INSPECTION REPORT
Sedimentation Structure
N5-E
Black Mesa Mine
Navajo County, Arizona
for
PEABODY COAL COMPANY

Dames & Moore
10139-011-22

Structure N5-E was inspected on September 4, 1985 by an interdisciplinary team of engineers from Dames & Moore. The purpose of the inspection was to assess the safety and general condition of the structure with respect to United States Department of Interior, Office of Surface Mining (OSM) regulations.

SITE PLAN N5-E

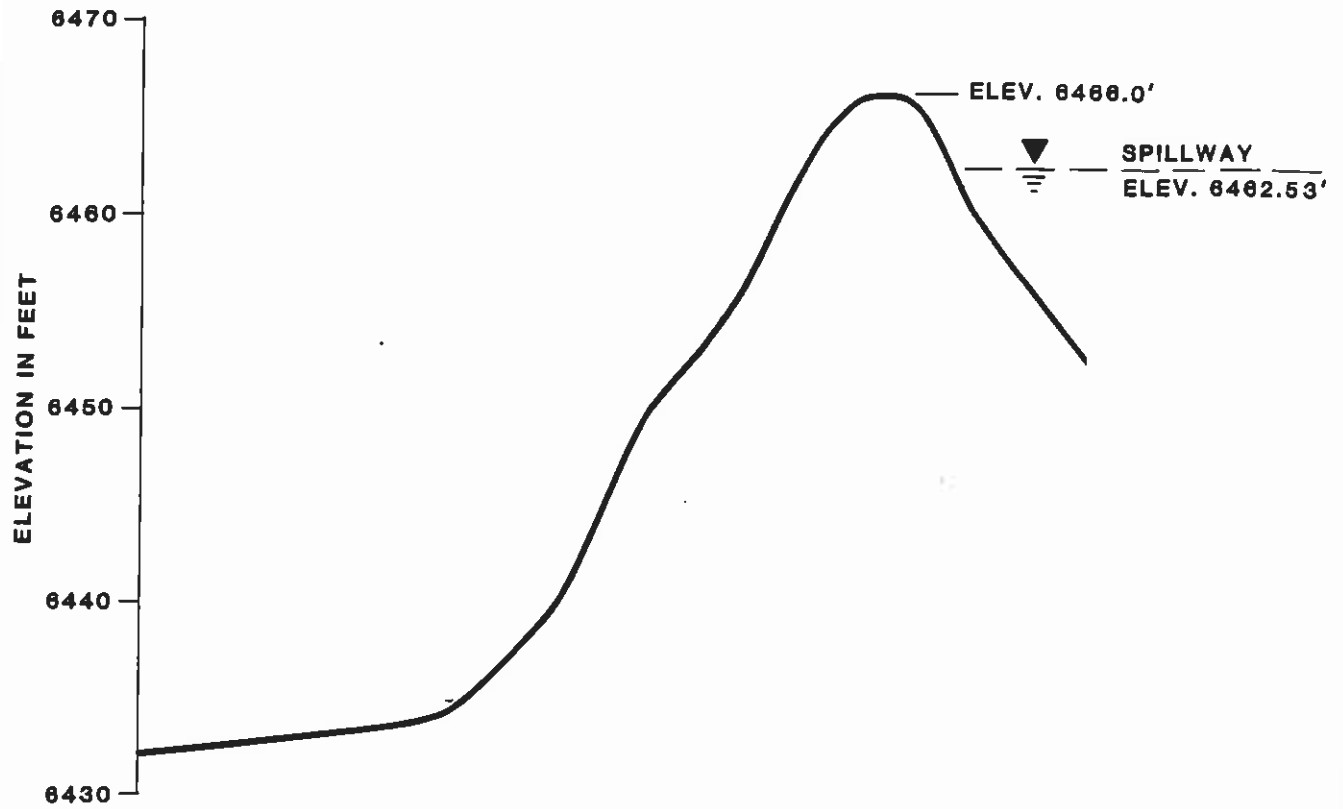
The storage capacity and spillway capacity of Structure N5-E are inadequate. The structure does not have an outflow channel. The storage capacity should be increased to 8.7 acre-feet by excavating the pond as shown on Plates 1 and 4. The embankment crest should be raised to elevation 6465.30 feet. A trapezoidal outflow channel should be constructed along the alignment shown in Plate 1. The channel profile is shown in Plate 4 and the required dimensions are shown in Plate 5. Both the spillway and outflow channel should be protected against erosion using geotextile and riprap as shown in Plate 5.

EXISTING
MAXIMUM CROSS-SECTION
A-A'
N5-E

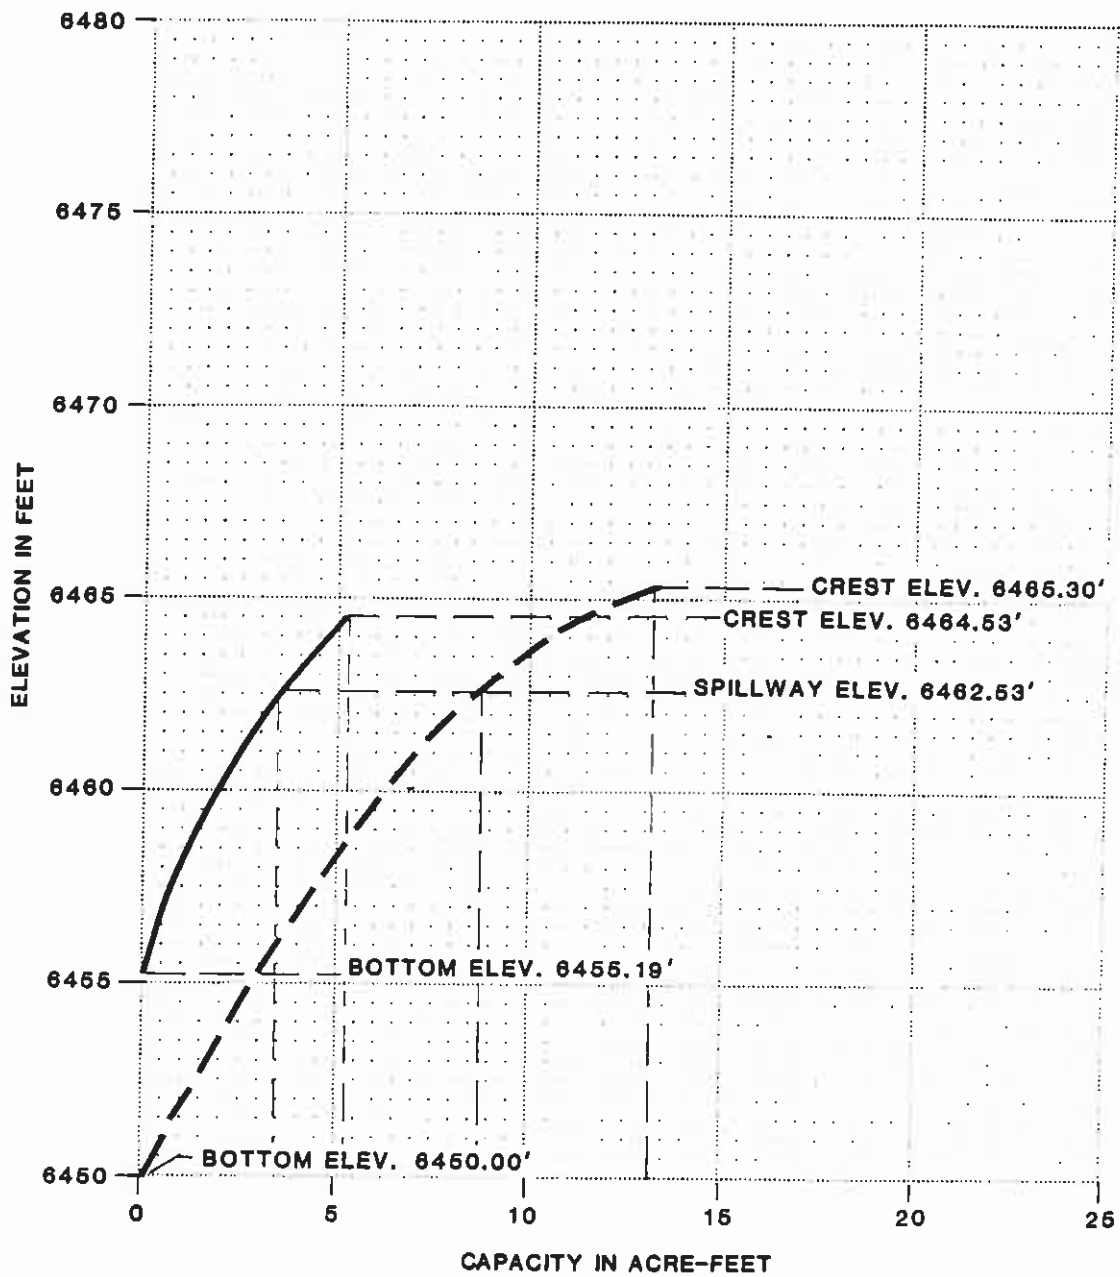
The N5-E embankment is lower in height; however, the downstream slope is steeper than the category standard; therefore, the embankment has factors of safety less than the design minimum.

The inspection of Structure N5-E indicated that the only geotechnical problem is rill erosion on the upstream slope and the side slopes of the spillway channel. Correction of erosion is considered a periodic maintenance task and does not require remedial action. The downstream slope should be flattened to 2.5 horizontal to 1 vertical to meet stability requirements.

VOLUME-ELEVATION CURVE N5-E

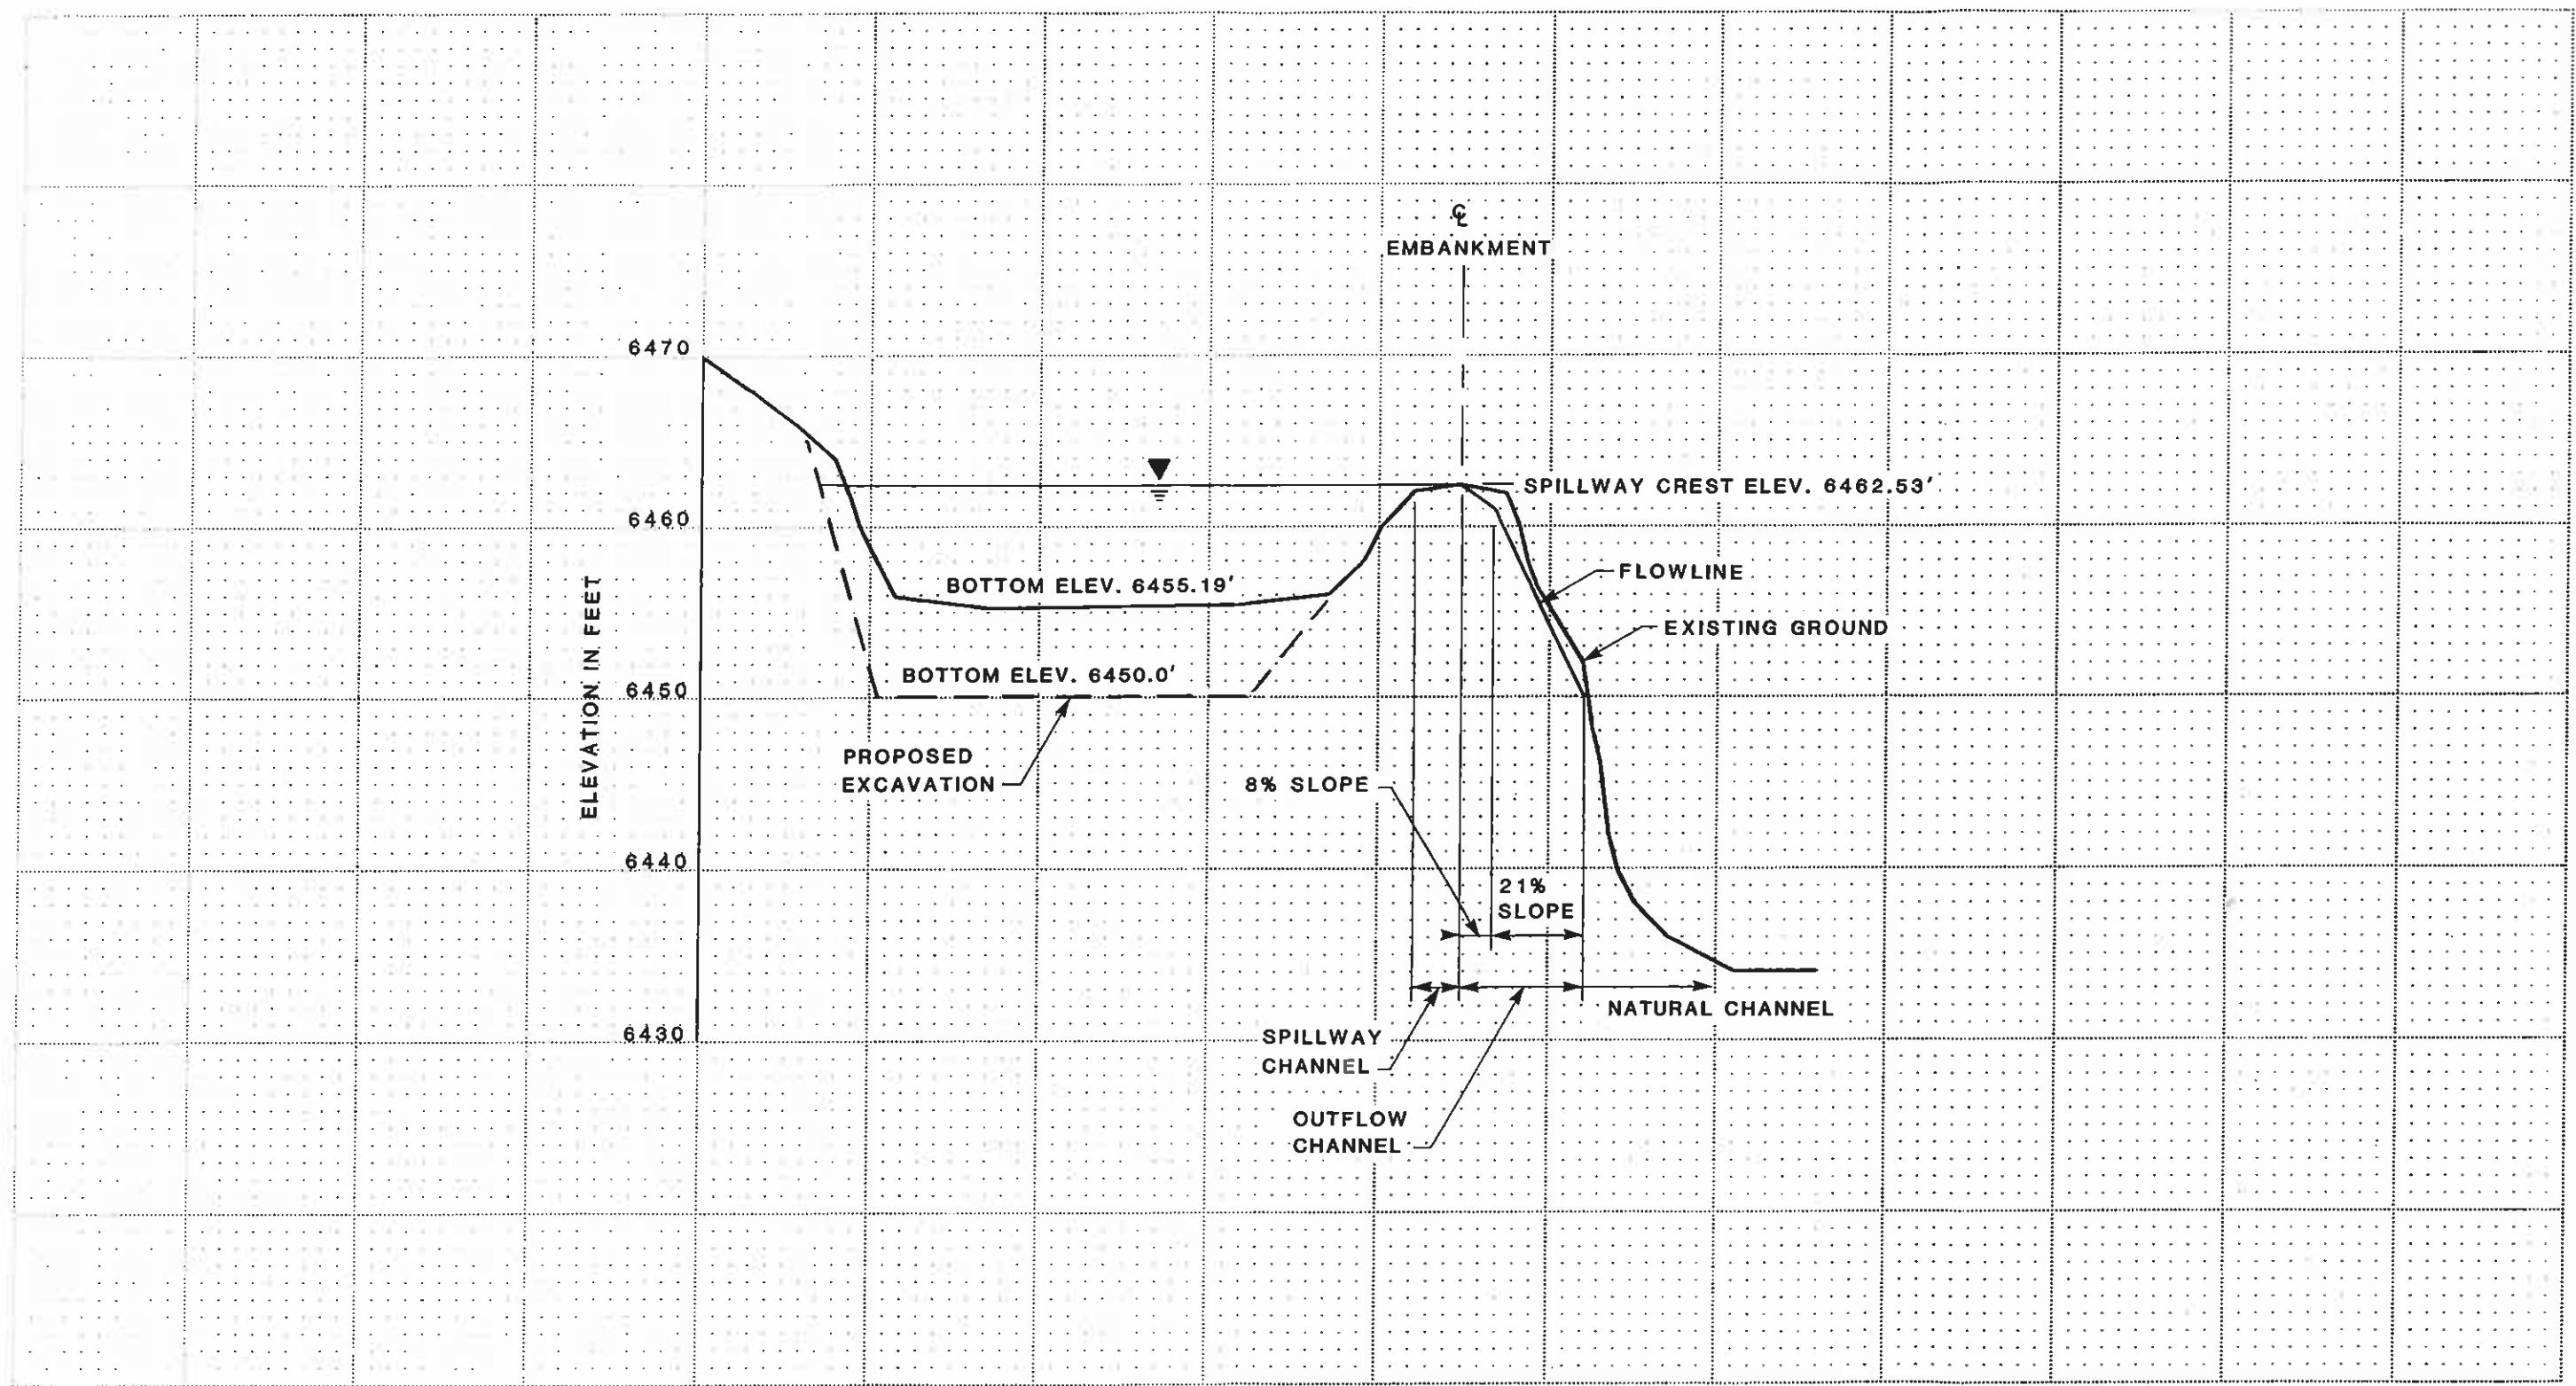
The impoundment volume-elevation curve is based on site specific surveys conducted for Peabody Coal Company's August 1984 inspection, and 1985 resurveys, where available. Additionally, the most current topographic maps available were used in developing Plate 3, Volume-Elevation Curve, N5-E.
